Process Sheet

Customer : CU-DAR001 Dart Helicopters Services	Drawing Name : X-TUBE AS 350/355 HI FWD
Job Number : 40421	
Estimate Number : 13224	
P.O. Number :	Part Number : D350748141TRN
This Issue : 10/07/2008 S.O. No. :	Drawing Number : D350-748-141 REV D
Prsht Rev. : NC	Project Number : N/A
First Issue : / / Type : CROSSTUBES	Drawing Revision : D
Previous Run : 40420	Material :
Written By :	Due Date : 24/07/2008 Qty: 1 Um: Each
Checked & Approved By : <u>JUD 08.7.10</u>	
Comment : : Est Rev:A New Issue 08-03-06 DD verified by:ec : Est Rev B Removed polish 08.04.02 EC verified by : DD : Est Rev C Remove LPS-3 08.06.23 EC verified by DD

DART AEROSPACE LTD	Work Order: 40421
Description: Crosstube Assembly (AS350/355 High Fwd)	Part Number: D350-748-141
Inspection Dwg: D350-748-141 Rev: D	Page 1 of 1

DESIGN <i>QP</i>	DRAWN BY <i>QP</i>	DART AEROSPACE LTD HAWKESBURY, ONTARIO, CANADA	
CHECKED <i>JP</i>	APPROVED <i>JP</i>	DRAWING NO. D350-748-141	REV. D SHEET 1 OF 3
DATE 06.10.31		TITLE CROSSTUBE (AS 350/355 HI FWD)	SCALE NTS
A	06.03.31	NEW ISSUE	
B	06.06.30	ADD D6017-115 & PRIME AND PAINT	
C	06.08.14	ADD CAD PLATING	
D	06.10.31	MAG. PARTICLE AND CAD PLATE AS MFD.

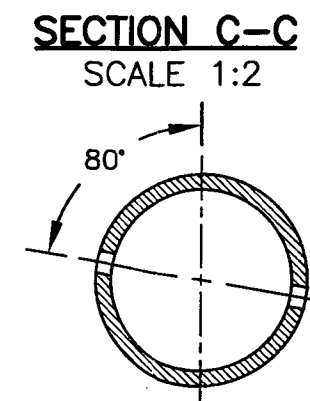
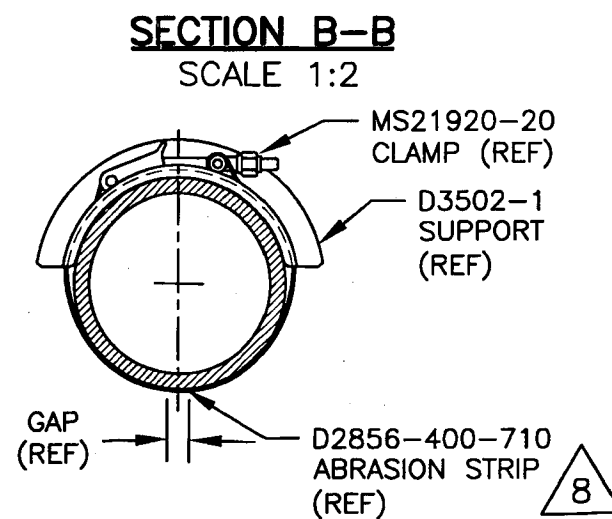
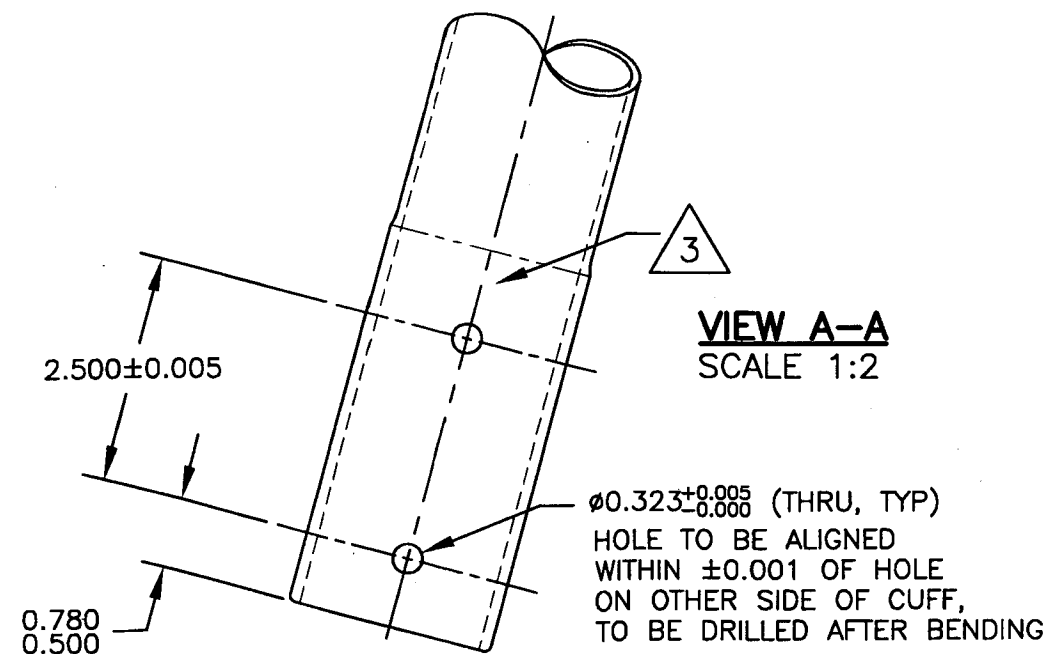
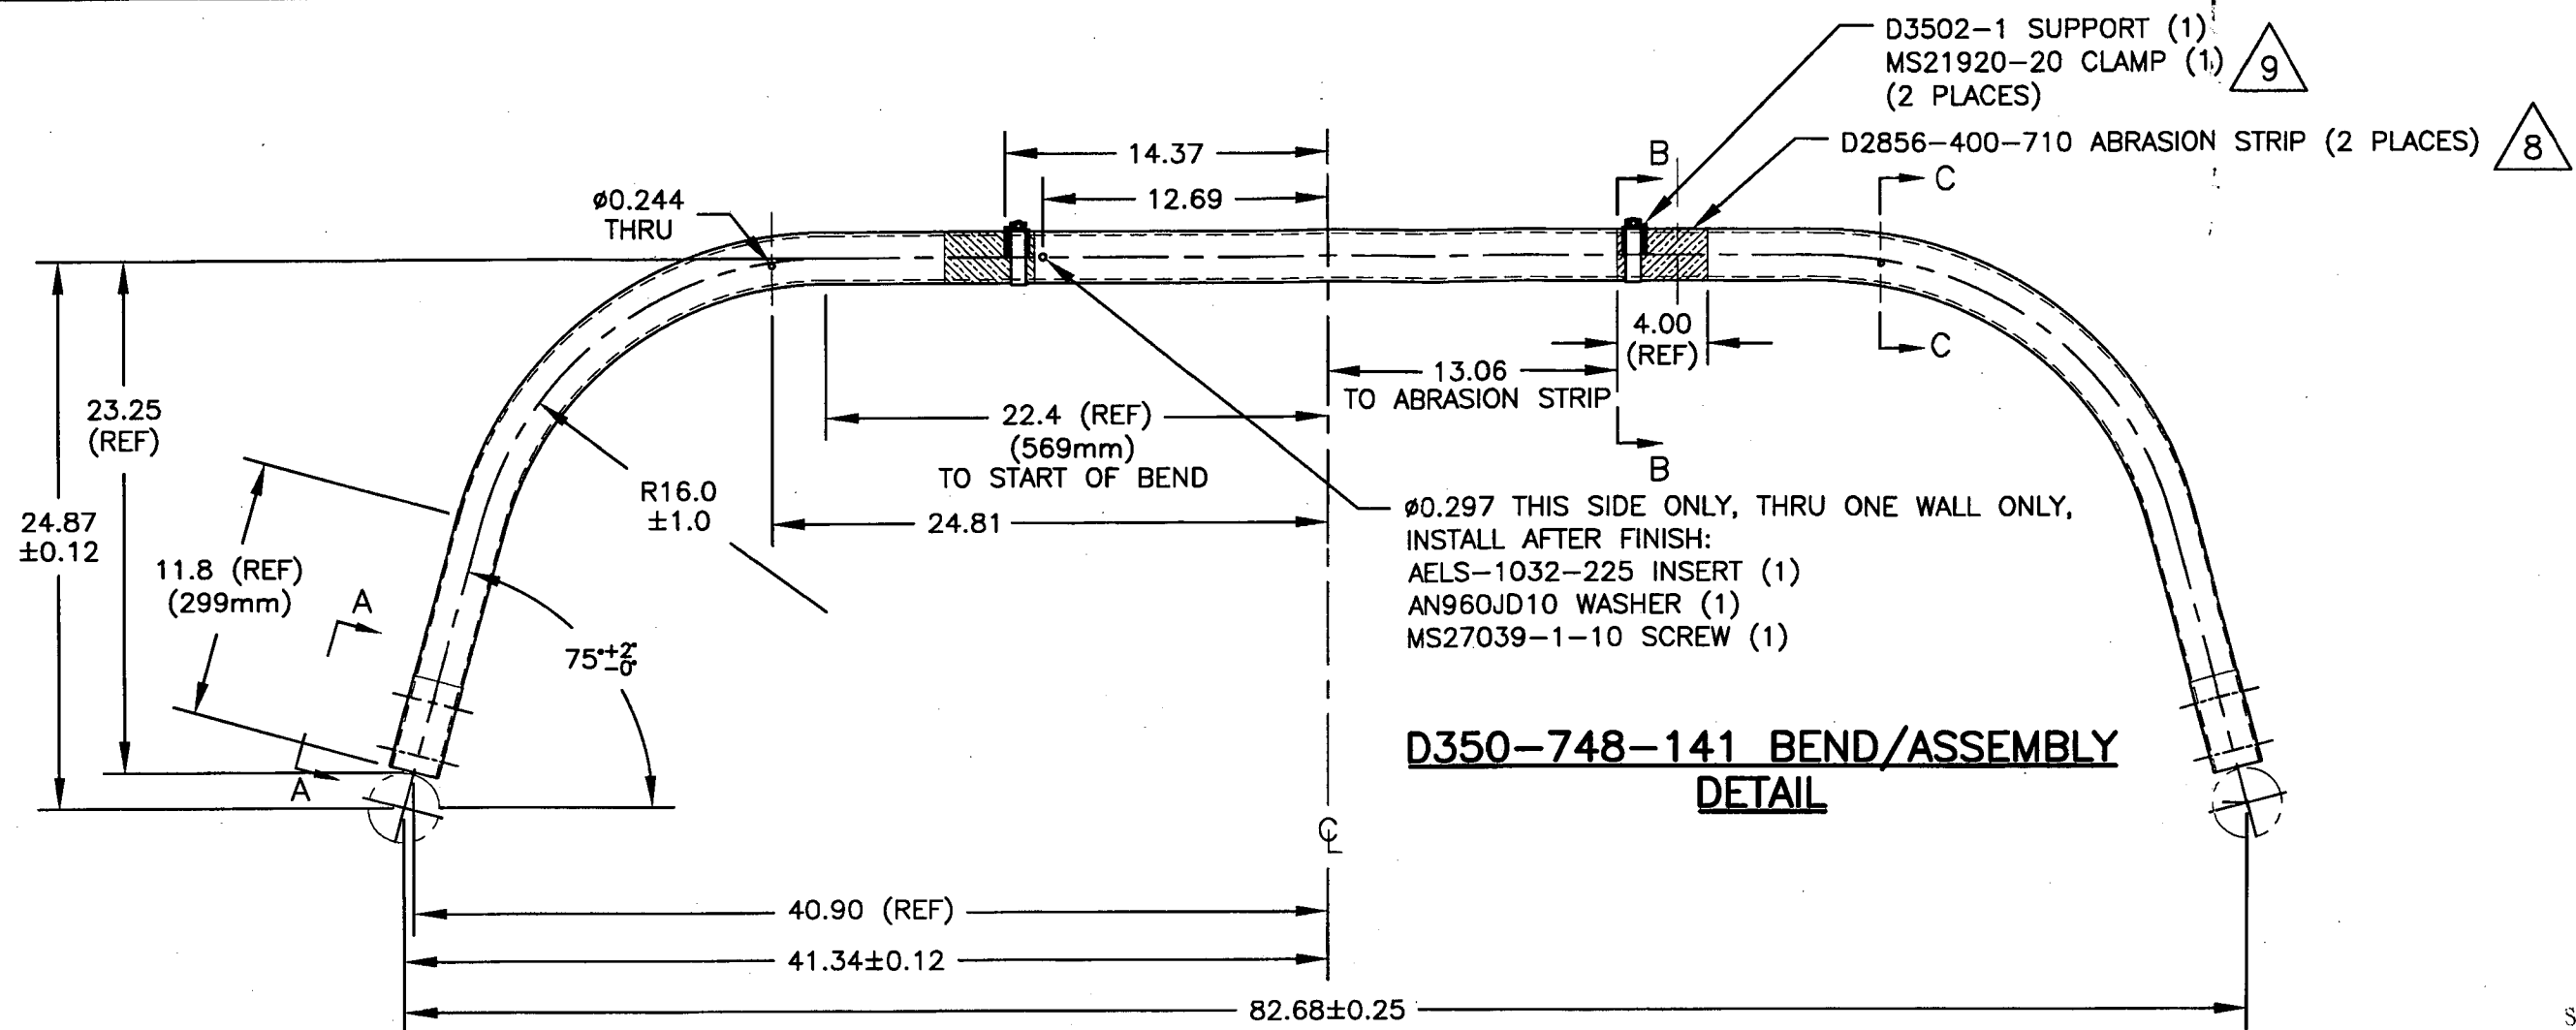
UNDER REVIEW!

CUFF BEND REDUCED
OK 07.02.22

D350-748-141 MACHINING DETAIL

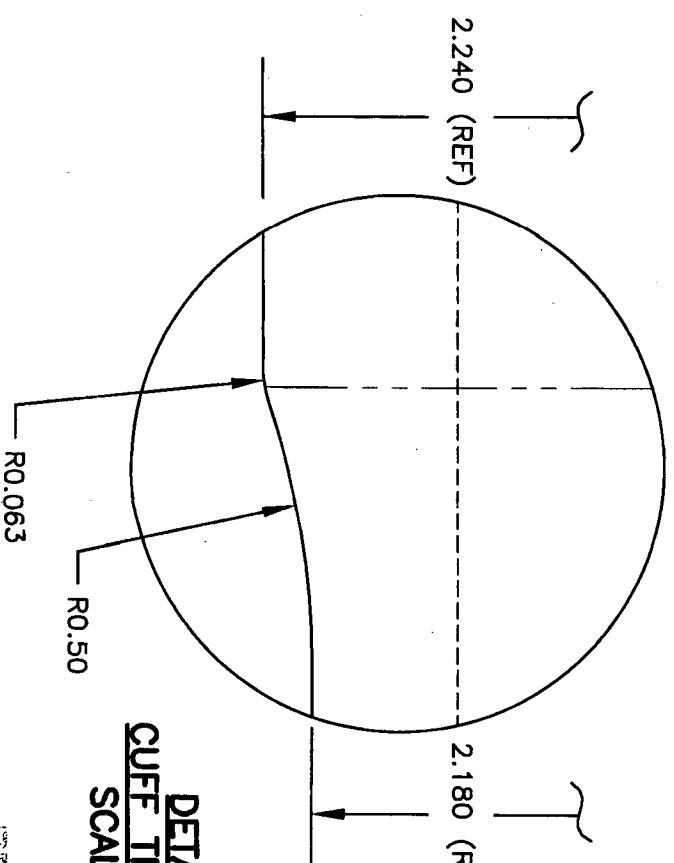
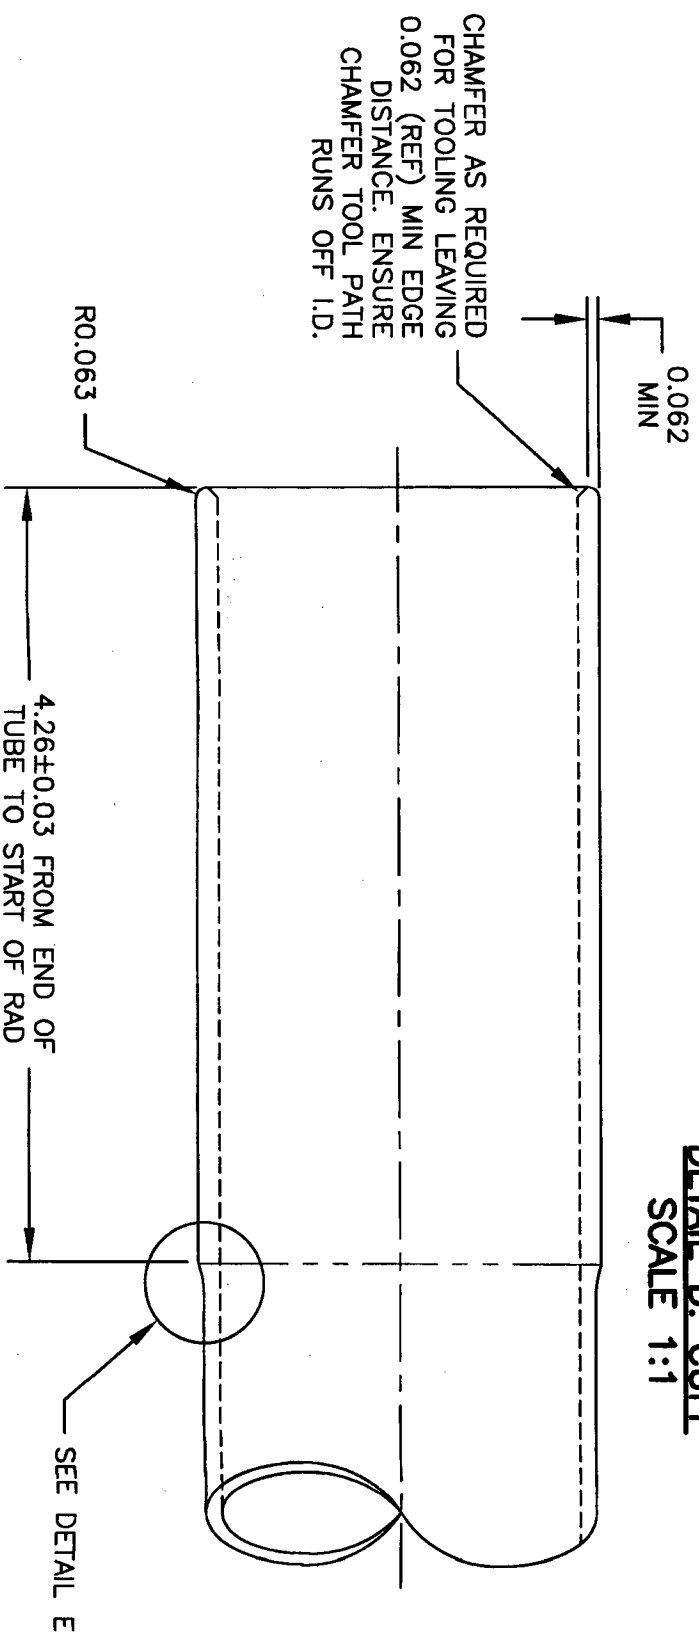
SHOP COPY
RETURN TO
ENGINEERING
UNCONTROLLED COPY
SUBJECT TO AMENDMENT
WITHOUT NOTICE
WORK ORDER
NO. 40424
07/02/16
Cufe Jaws Reduced
to 40.710 ZL
